STAFF REPORT: NOVEMBER 12, 2025 MEETING

APPLICATION NUMBER: HDC2025-00641

ADDRESS: 3460 IROQUOIS

SCOPE: INSTALL GATE (WORK COMPLETED WITHOUT APPROVAL)

Façade. Staff photo, October 29, 2025.

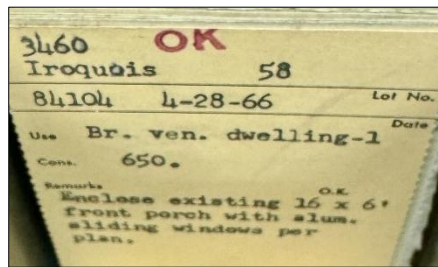
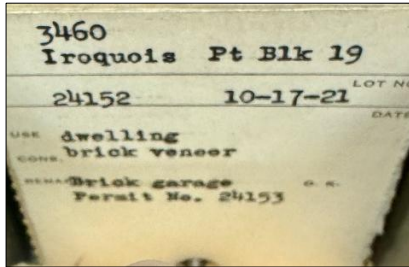
The property's driveway is to the left/north of the house, extending from Iroquois to the detached garage at the northeast corner of the rear yard. A wrought-iron-style gate installed at the northwest corner of the front porch bisects the driveway and encloses the rear yard.
